PROJECT NAME: STERLING HALL SCHOOL – PHASE 1 MASTER PLAN ADDITION

PROJECT No.: 00036-010-E-001

DATE: 2026-07-22

ADDENDUM No.: E01

scale: 1 : 50  
date: XX/XX/2X  
drawn: RLJG  
checked by: Checker  
project number: 00036.010.E001  
drawing number: E-902  
Revision: 3

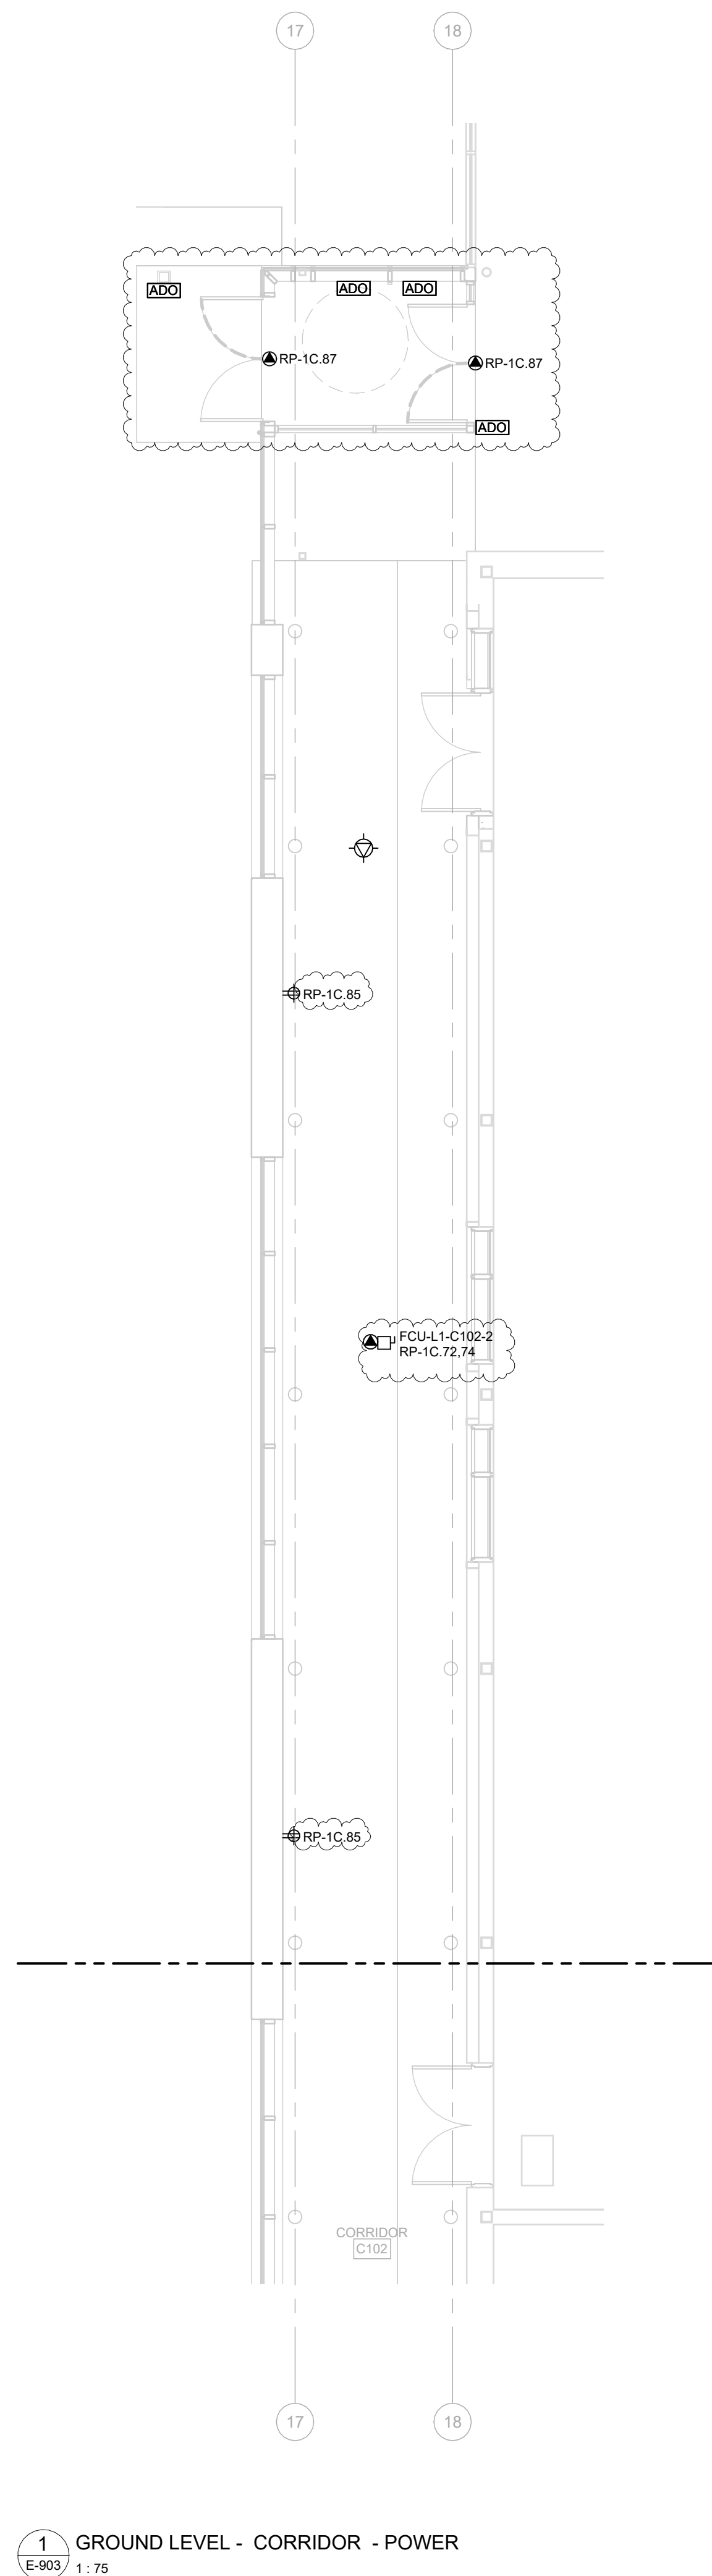
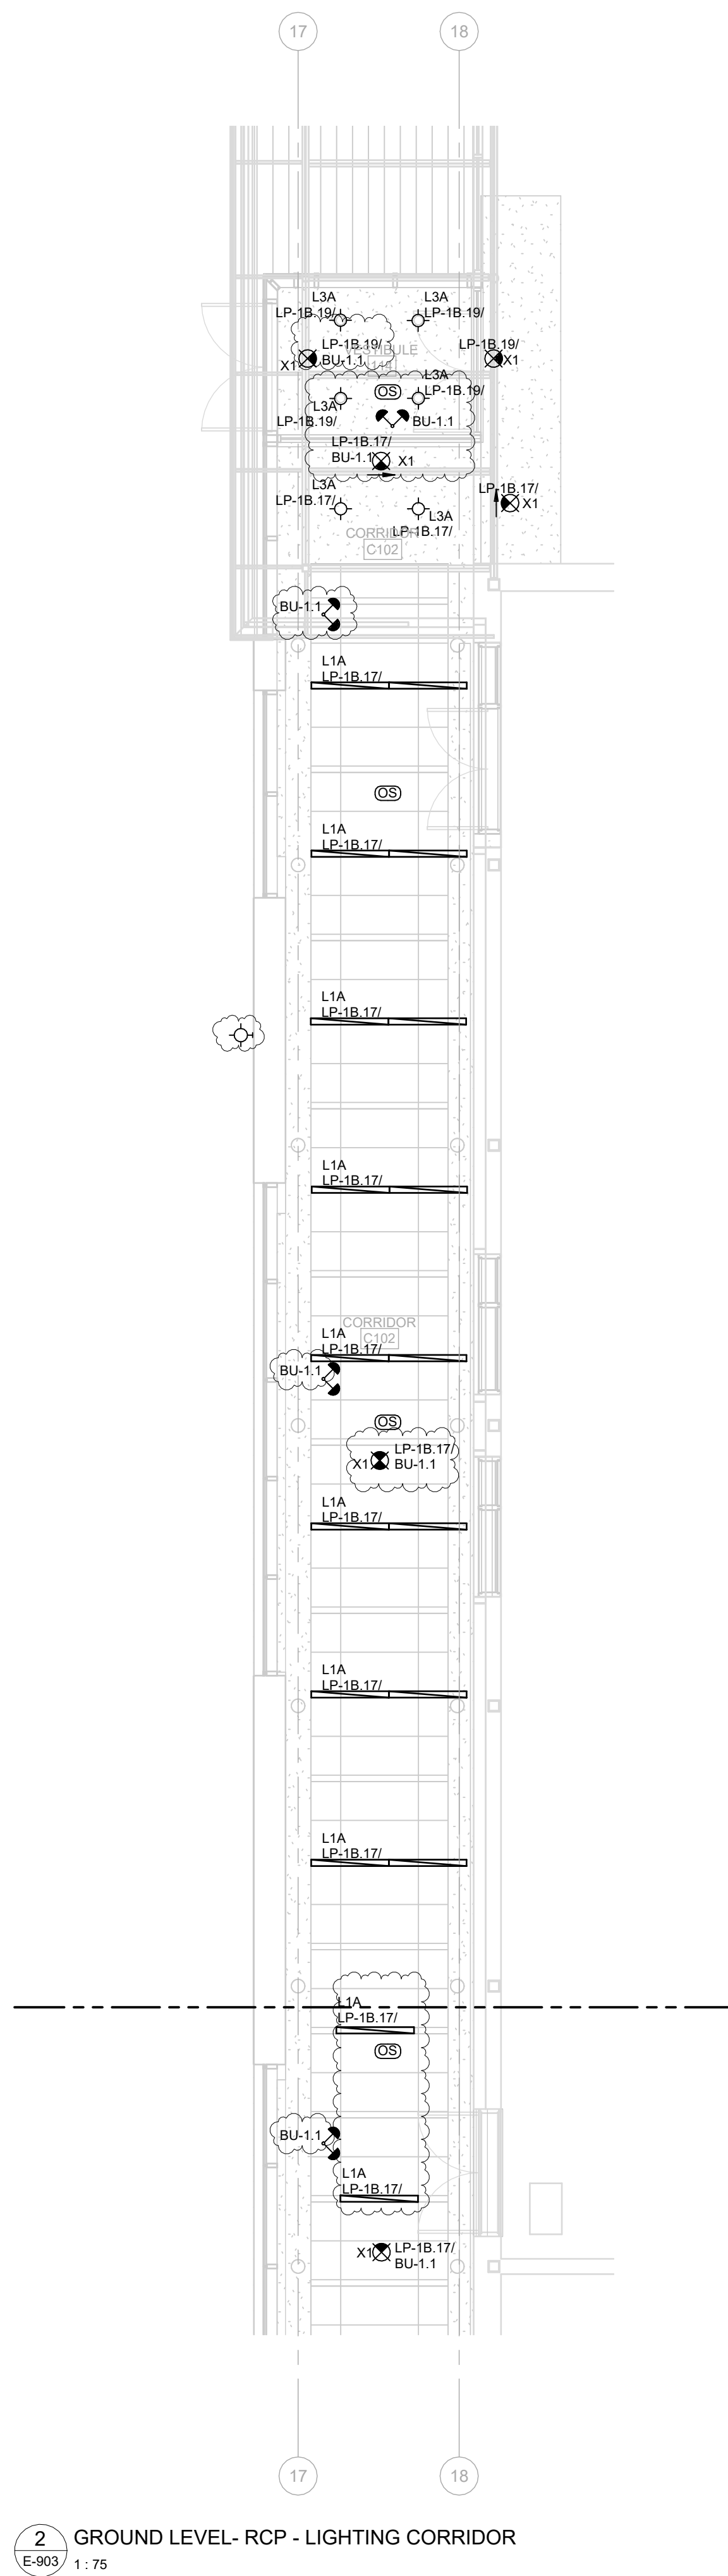
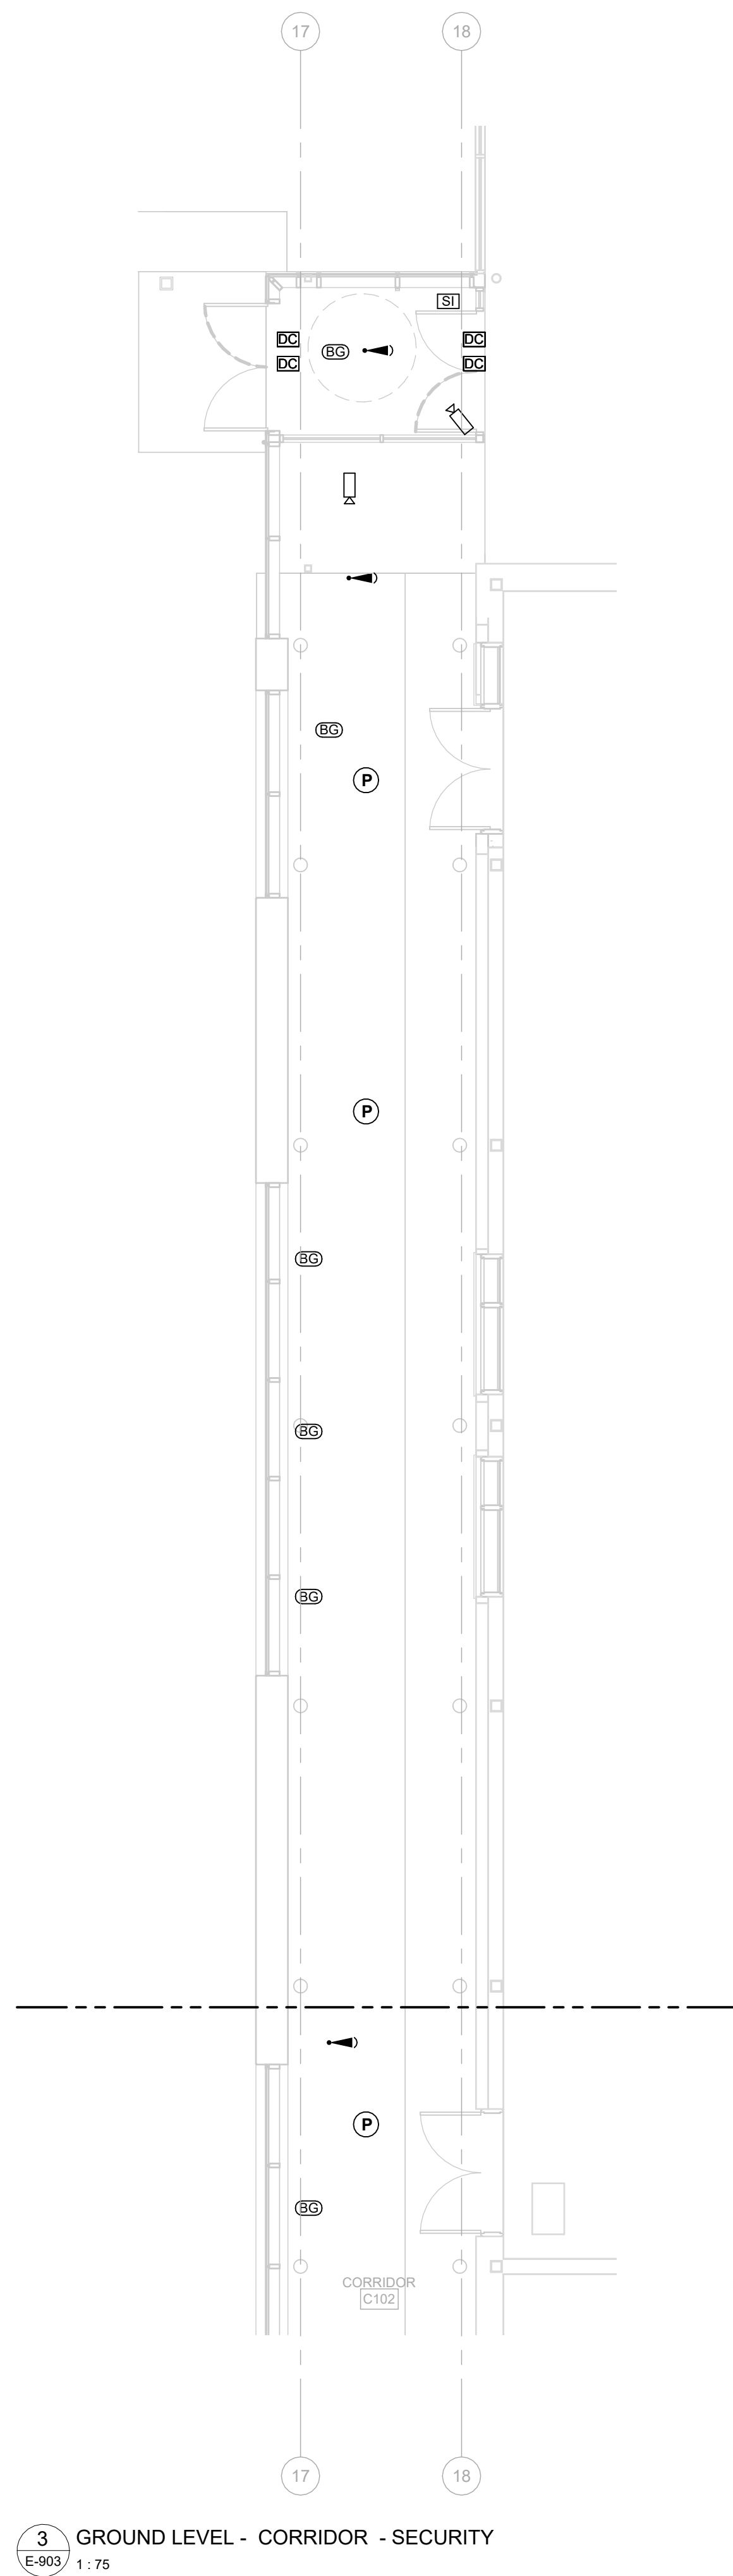
- 2.1.28 E-902: Add lighting circuits.
- 2.1.29 E-903: Add circuits. Revise lighting layouts. Add ADO push buttons.
- 2.1.30 ED-101: Clarify demolition scope.
